“AMENDMENT” OF THE PRELIMINARY DRAINAGE REPORT

Claremont Business Park 2 Filing No.1

JULY 2020

Refer to the preliminary plan application(SP197) drainage report for any additional comments that may be provided.

DETENTION BASIN OUTLET STRUCTURE DESIGN

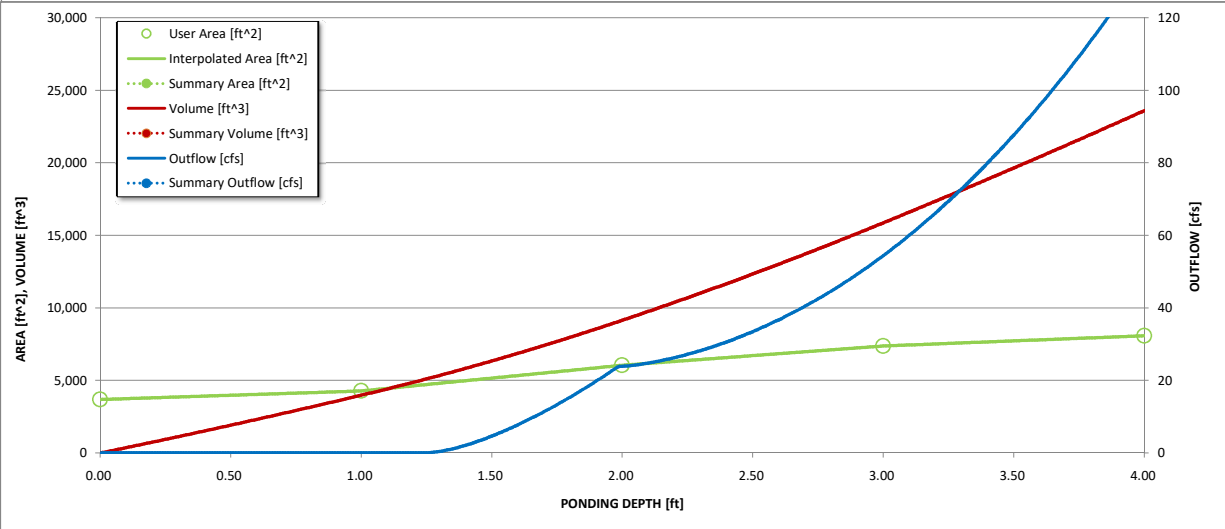
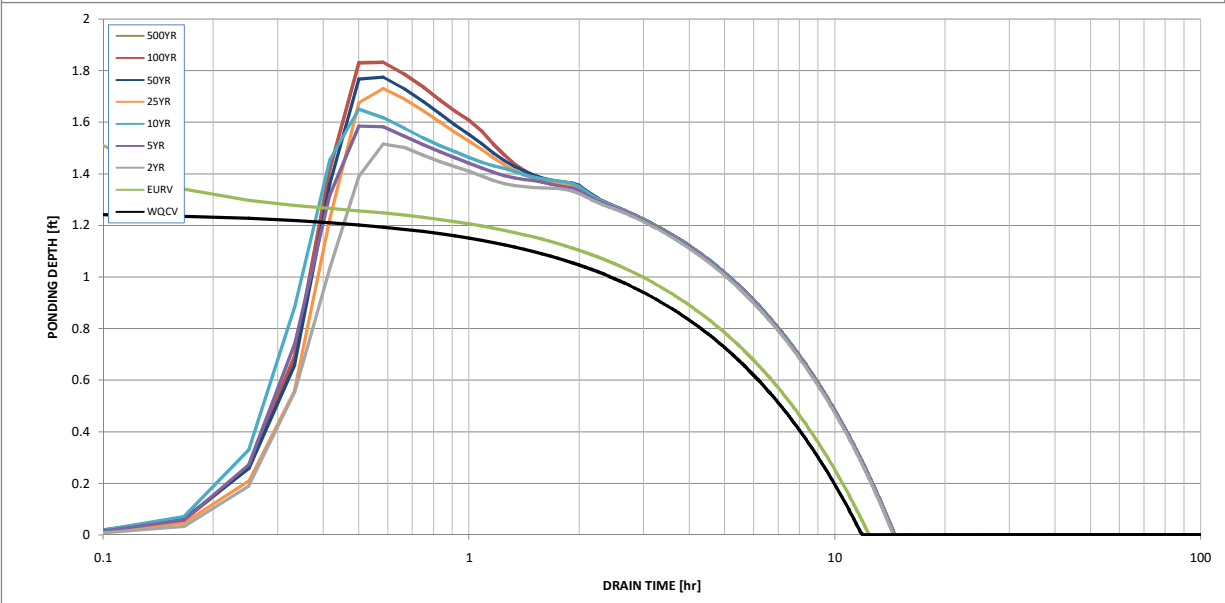
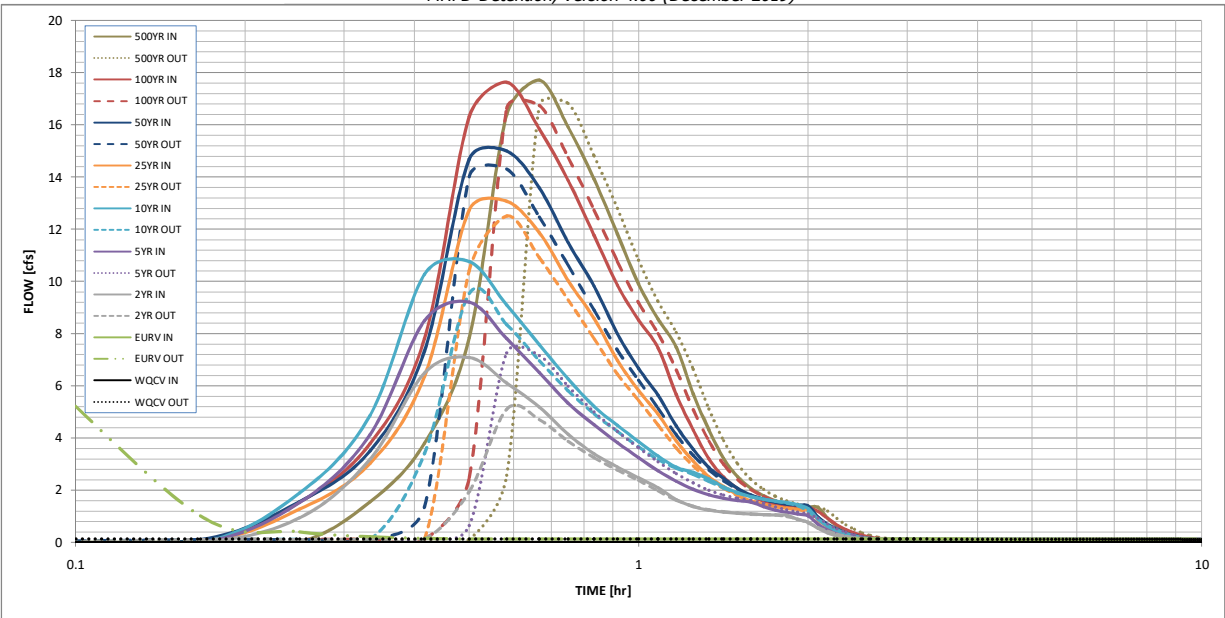
Please resolve the error

PROJECT NO. 44-037A	FILE: \dwg\Eng Exhibits\44037-PDRM.dwg	DATE: 06-29-2020
DESIGNED BY: GW	SCALE: HORIZ: 1"=60'	VERT: N/A
DRAWN BY: CLP		
CHECKED BY: VAS		
SHEET 1 OF 1		PDM01

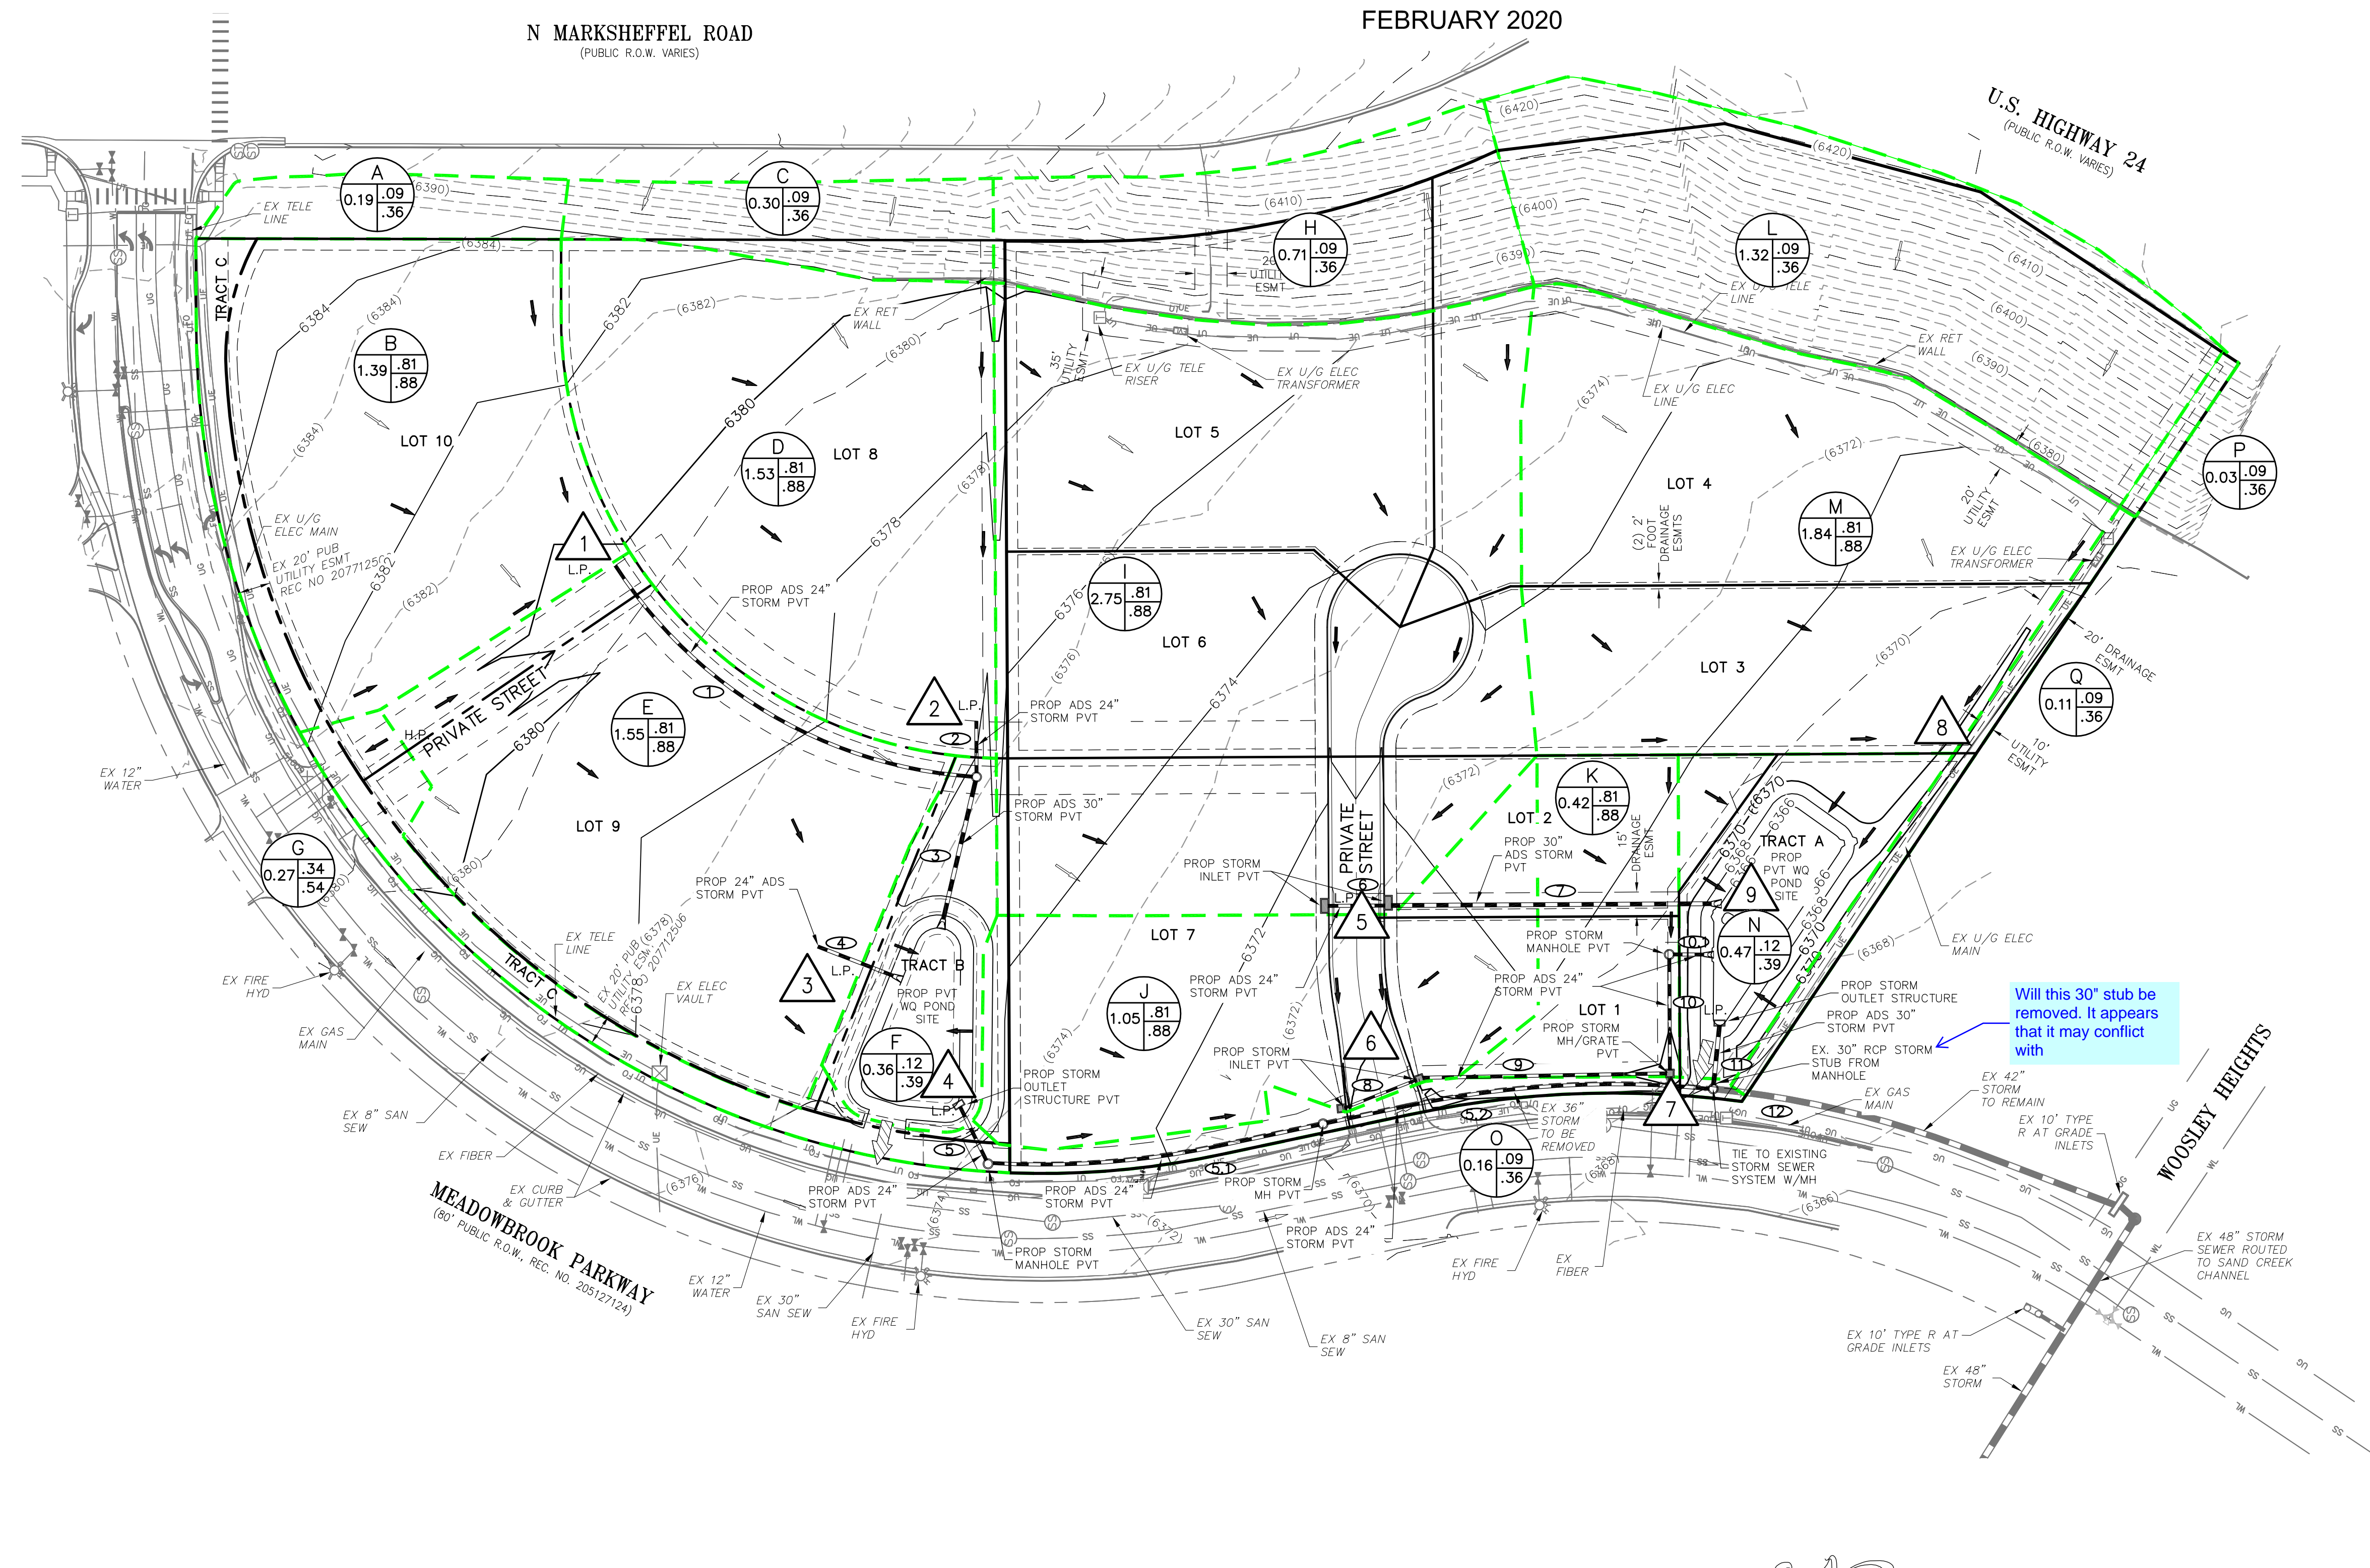
The callout for the 36" pipe is located in basin O. revise accordingly.

It appears that the existing 30" stub may conflict with your proposed 30" ADS pipe. Please clarify.
